Access Compliance Report

Public Rights-of-Way

(Curb Ramps)

Intersection ID: 31591	Main Street: HUGUE_WY	Cross Street: BLUE_BRIDGE_CT	Location: SE
ADA ID: 45628DD58E47	Ramp Type: PerpDiag	Initial Pass/Fail: Fail	Overall Compliance: No
Severity Score: 12.5			
Codes/Mitigation Info/Possible Solution		Field Measurements/Component Compliance

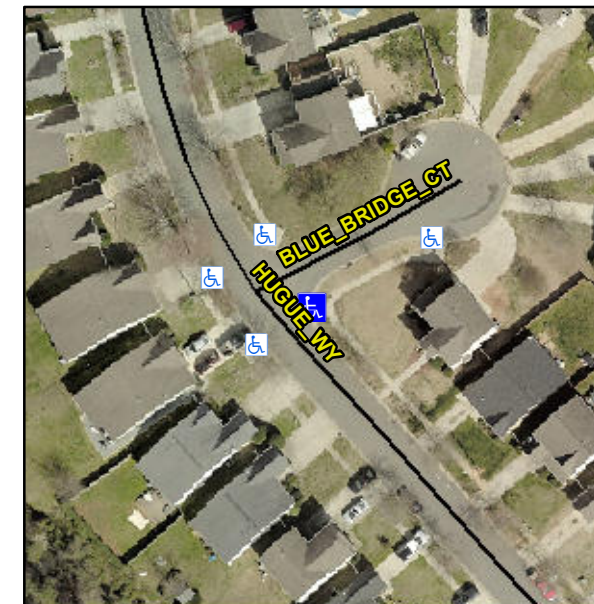
Not Found, R304.2.2

Compliance	Description	Data	Compliance	Description	Data
N/A	Ramp Length (in)	81.0	No	Ramp Slope (%)	8.4
Yes	Ramp Width (in)	67.0	Yes	Ramp XSlope (%)	1.0
N/A	Flare Type LT	N/A	N/A	Flare Type RT	N/A
N/A	Flare Slope LT (%)	N/A	N/A	Flare Slope RT (%)	N/A
N/A	Flare Traversable LT?	N/A	N/A	Flare Traversable RT?	N/A
N/A	Landing Length (in)	N/A	N/A	DWS Provided?	N/A
N/A	Landing Width (in)	N/A	N/A	DWS Contrast?	N/A
N/A	Landing Slope (%)	N/A	N/A	DWS Length (in)	N/A
N/A	Landing X Slope (%)	N/A	N/A	DWS Full Width?	N/A
N/A	Landing Curb? (Y/N)	N/A	N/A	DWS Offset (in)	N/A
N/A	Shared Landing?	N/A			
N/A	Gutter Ponding?	N/A	N/A	Gutter Slope (%)	N/A
N/A	Gutter Lip Ht (in)	N/A	N/A	Gutter X Slope (%)	N/A
N/A	Painted X Walk1?	No	N/A	Painted X Walk2?	No
	X Walk 1 Direction	To NW		X Walk 2 Direction	To SW
N/A	X Walk 1 Width (in)	N/A	N/A	X Walk 2 Width (in)	N/A
	X Walk 1 Slope (%)	1.0		X Walk 2 Slope (%)	0.2
	X Walk 1 X Slope (%)	1.0		X Walk 2 X Slope (%)	0.8

Remove & Replace Curb Ramp With Two New Directional Ramps or Equivalent.
